Roof and Wall Cladding at the Tyne's Bay Saltwater Reverse Osmosis Plant

Request for Proposals No.: **2025-006Q-MPW**

Addendum No. 0001

Addendum Type: Clarification Questions and Additional Information

REV. NO. 1
SHEET NO. E7

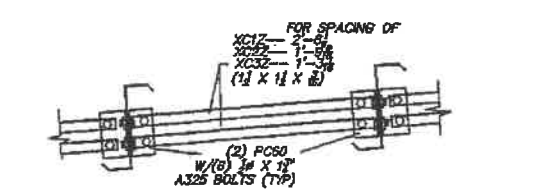
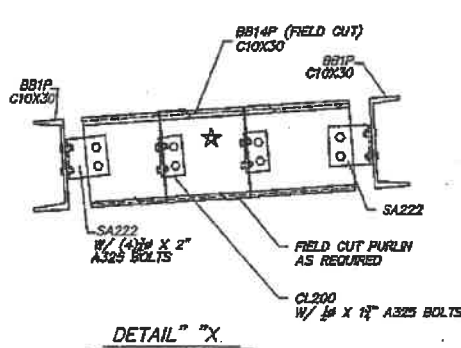
Q1) Please show size, location and quantities of skylights on drawing?

A) Please see the attached “existing” drawings which detail the sky light locations and measurements.
